Reply point by point

The authors present an interesting approach to increase knowledge about the internal structure and hydraulic processes of rock glaciers. The paper is well written, description of the site, methods and results seem complete, and the results are very promising. I like the original and minimalistic approach to collect and preserve enough water for the experiment.

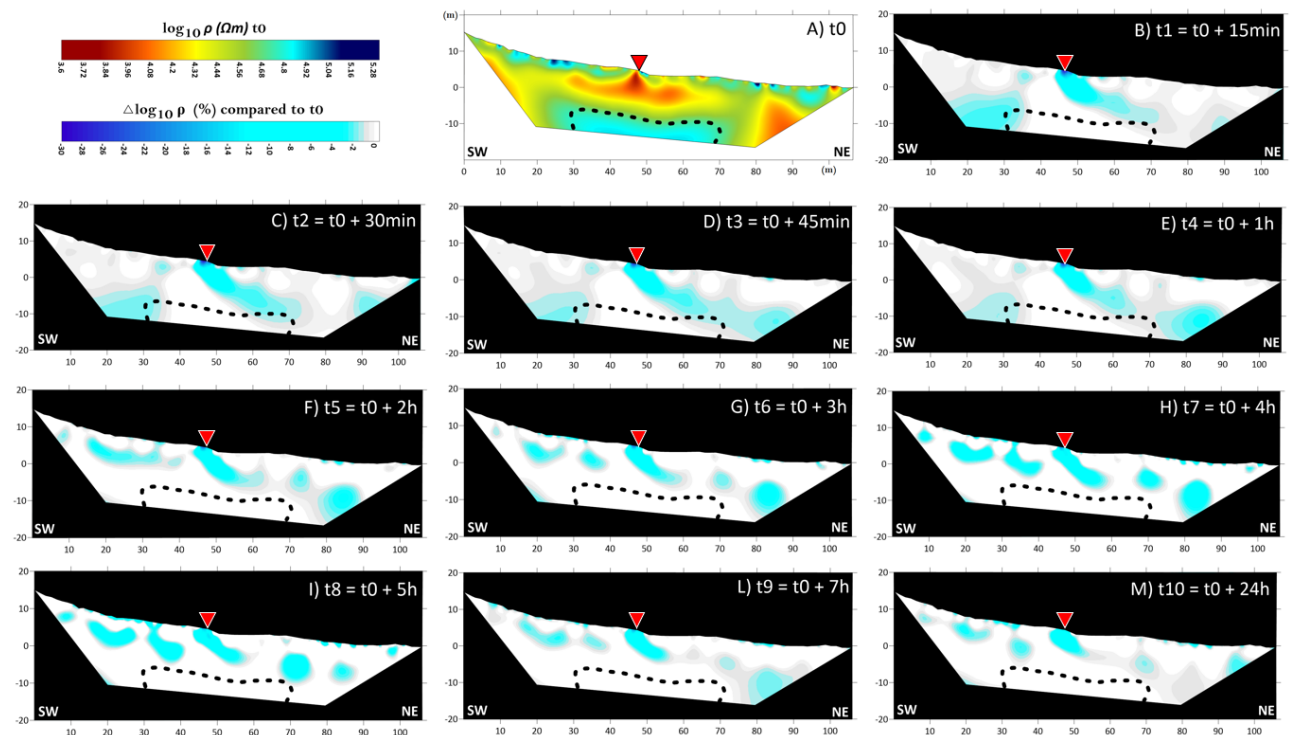
- How did you calculate the percentage change in resistivity? From absolute resistivity values or from the logarithm of the resistivity values? I strongly recommend using the logarithm for these calculations in order to avoid emphasizing changes in the high resistivity zone:

$$(\log_{10}(\text{res}_{t1}) - \log_{10}(\text{res}_{t0})) / \log_{10}(\text{res}_{t0}) * 100$$

- I would prefer to see the tomogram t0 plotted with a logarithmic colour scale (common standard in the community).

- as mentioned before I strongly recommend to plot the resistivity change based on logarithmic values, which will smooth the overall resistivity change and balance changes in low and high resistivity zones with a probable positive effect on interpretability...

- indicate the point of injection in Fig. 3A (as far as I understand it is in the center of the profile) --> how do you explain resistivity decrease upslope of this point?? Snowmelt? Seasonal active layer thaw?

Reply: We really appreciate the suggestion of the anonymous reviewer. In the results presented in Figure 3 of the submitted manuscript, the percentage variations were calculated from absolute resistivity values. We applied the approach proposed by the reviewer and we used the logarithmic resistivity values to define % changes between t_0 and other time steps. The new output is very similar to our previous results but, as correctly highlighted by the reviewer, the approach avoids over-emphasizing high variations. Therefore, in the revised version of the manuscript we will present the results of the time-lapse experiment (new Fig.3 – see below) obtained applying the approach suggested by the reviewer, which clearly improved the final output of the survey.

Reply: In the revised manuscript we will plot it in logarithmic scale.

Reply: In the revised manuscript we will plot the resistivity change based on logarithmic values, as discussed in the reply to the first general comment.

Reply: We thank the reviewer for the useful suggestion and in the revised manuscript we will plot the tomograms with an indication of the injection point. Regarding the negative % resistivity changes upslope the injection point, we presented the following explanation in lines 160-164: "...the presence of boulders and large rocks at various depths can lead to local reductions of the permeable area, causing funnel flow, and/or a splitting of flow paths (Hartmann et al., 2020). Splitting flow paths, due to the presence of large boulders, may have determined the infiltration of some injected water along the south-west direction and a local accumulation upslope of the injection point, which resulted in the observed negative resistivity variations." During the infiltration experiment there was no snow cover on the rock glacier and, since the infiltration experiment was carried out in few hours, we think that we can exclude any link with active layer thawing. Moreover, as specified in line 104, no rain or uncontrolled water contribution happened during the 24 hours of the experiment.
